Poppet/Relief Valve Spring – 3.0 Litre

NOTICE

This is a revision of 3.0 Litre Service Bulletin 96-20. Destroy Bulletin 96-20 1196 and insert this revised (08/10/98) Service Bulletin 96-20. Changes are underlined.

1997 225/250 HP, 3.0 Litre

- a - Filler block
- b - Gear housing

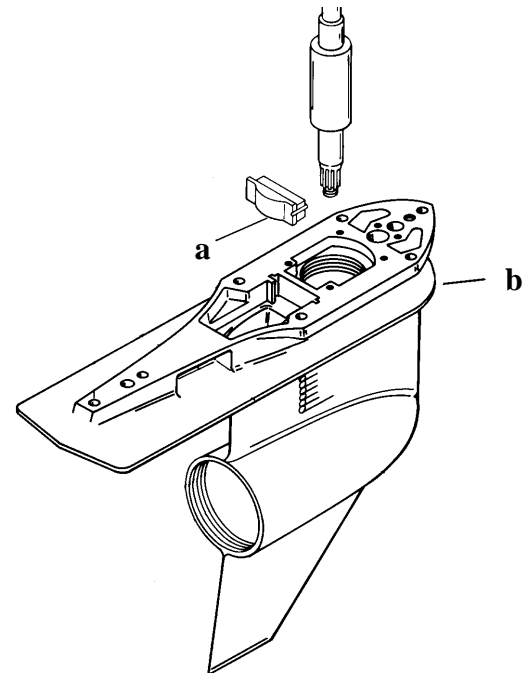
Remove the lower unit, and closely inspect the rubber filler block. If the filler block has a burnt appearance make the following correction.

- 1 - Exhaust Plate
- 2 - Carrier
- 3 - Grommet
- 4 - Poppet/Relief Valve
- 5 - Spring
- 6 - Gasket
- 7 - Inner Plate
- 8 - Diaphragm
- 9 - Washer
- 10 - Screw
- 11 - Gasket
- 12 - Outer Cover
- 13 - Bolts [Torque bolts to 20 lb. ft. (27.0 N-m)]

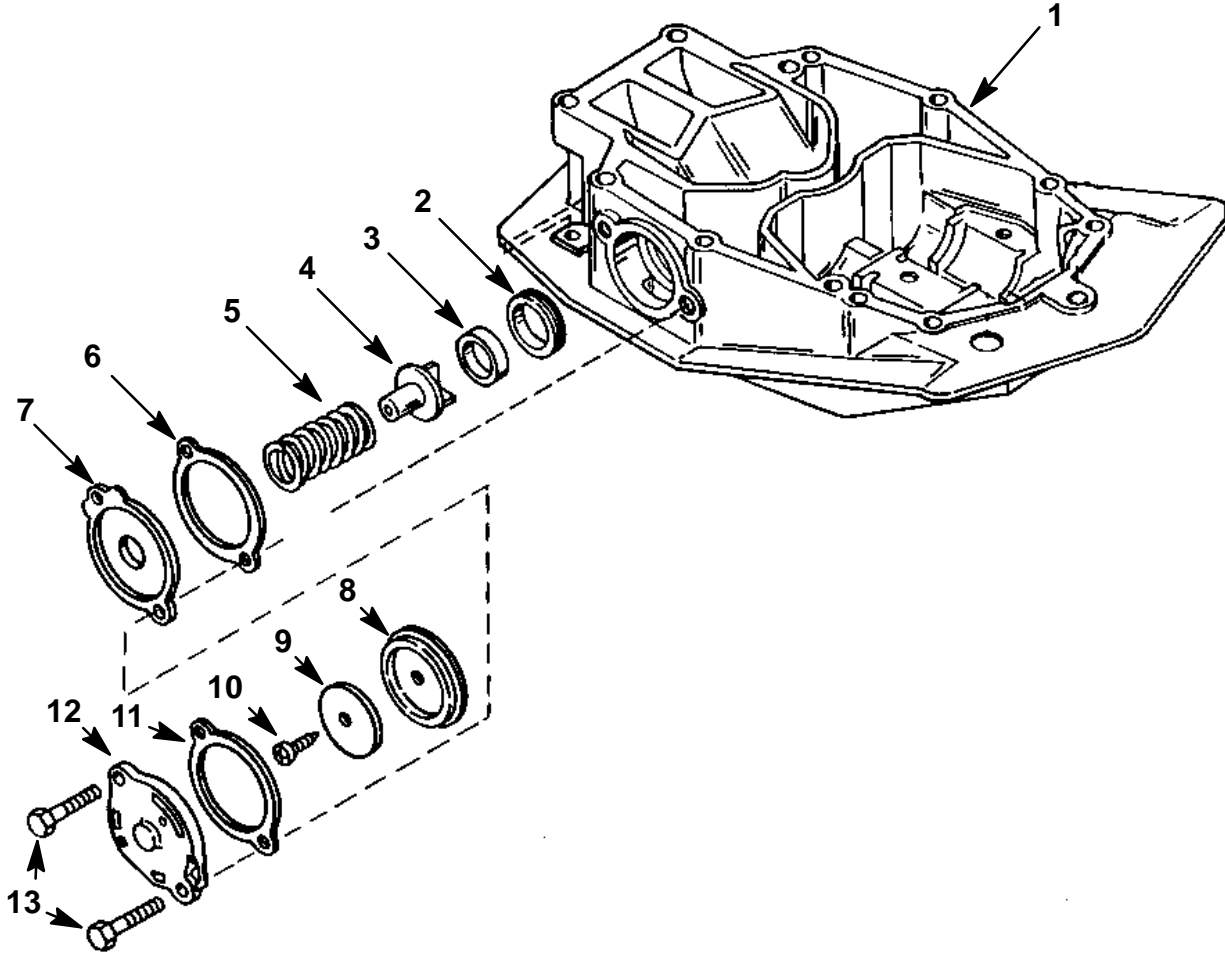
There have been some reports of propeller hub, and bearing carrier seal burn-out on 1997, 3.0 Litre outboards. It has been determined that engines operated in the 2000 RPM range may not receive sufficient water supply to the exhaust system, resulting in excessive exhaust temperatures. This lack of water is due to the poppet/relief valve spring having incorrect tension, not allowing the poppet/relief valve to open in this RPM range. If a failure of the propeller hub or carrier seals due to a lack of water is suspected, make the following inspection.

Remove the two bolts that retain the poppet/relief valve cover to the exhaust plate.

Remove the poppet/relief valve assembly from exhaust plate.

Remove the screw that retains the valve and spring to the inner poppet/relief valve plate.

Install the new poppet/relief valve spring P/N 24-854478.

Reassemble and install poppet/relief valve assembly using 2 new gasket P/N 27-88907.
